**DISTRICT OF SOOKE**  
**WWTP EXPANSION PROJECT 2022**  
**ADDENDUM NO. 3**

**August 22<sup>nd</sup>, 2022**

**Addendum Item 1 Responses to Questions from Bidders**

Figure 1 - Inlet Splitter Box Weir Opening

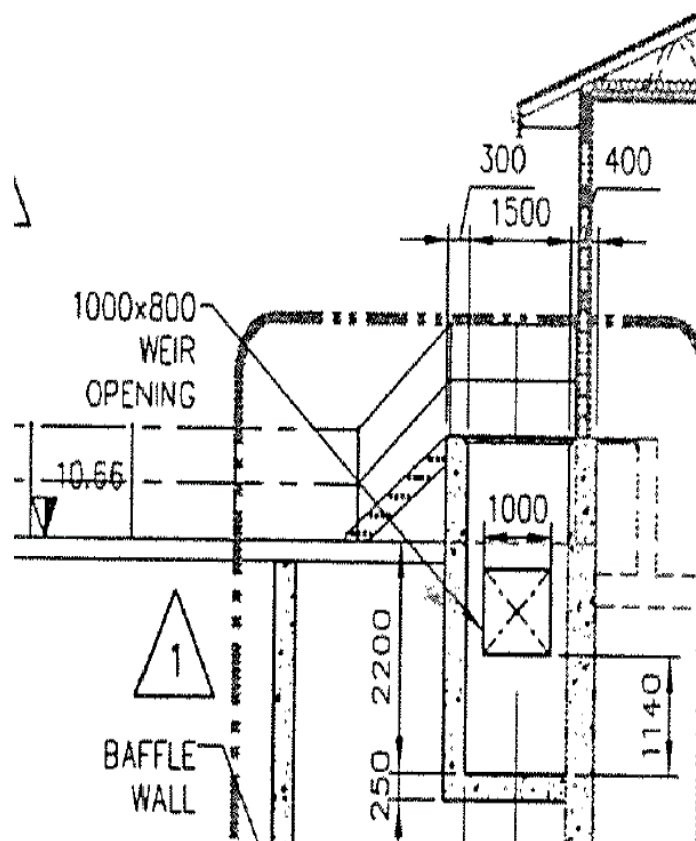
7. In tomorrow's addendum, if you could please also address the size of the slide gate size and height from the invert of opening to the operator elevation.

The design to match exactly with the downward opening weir gates in the original plant inlet box. Unfortunately, the shop drawings for these gates are not available. Referring to the as built drawings from the 2005 construction we can provide the following data  
The weir opening in the concrete structure is 1000 mm X 800 mm (see Figure 1)
